## ZONING BOARD OF APPEALS

**To:** Zoning Board of Appeals Members  
**From:** Adrianna Henriquez, Clerk  
**Date:** April 30, 2020  
**Subject:** Materials for **May 6, 2020** Public Hearing

## PUBLIC HEARING MEMORANDUM

Subject: **Traffic Engineering Peer Review –  
Proposed Mixed-Use Development  
15 Riverdale Avenue  
Newton, Massachusetts**

Figure 1. Conceptual Improvements, California Street and Bridge Street Intersection

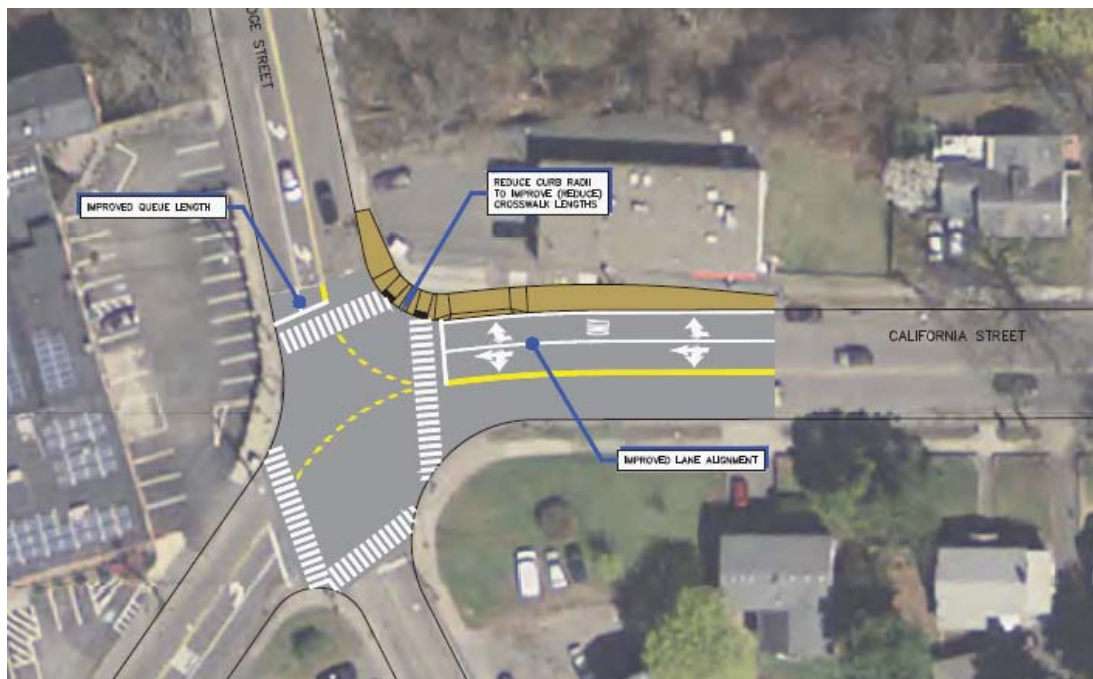
MDM states that the applicant is proposing to work with the City on a few pedestrian improvements to the intersection of California Street and Bridge Street and the intersection of California and Los Angeles Streets. Specifically, the applicant proposes a bump out at California and Bridge Streets to shorten crosswalks and better align the California Street westbound approach. As the intersection of California and Los Angeles Streets, the applicant proposes new Americans with Disabilities Act-compliant ramps, and a new pedestrian crossing with a rapid reflectorized flashing beacon (RRFB). The applicant is also proposing two pedestrian connections to the Forte Park. MDM also states that the applicant is continuing to work with abutters to install a sidewalk along the eastern portion of Los Angeles Street, staff suggests that the application provide an update on this improvement at the public hearing. The Planning Department will consult with the Transportation Division of Public Works regarding the improvements at the intersection of Bridge and California Streets, and well as the proposed RRFB at the intersection of California and Los Angeles Streets.
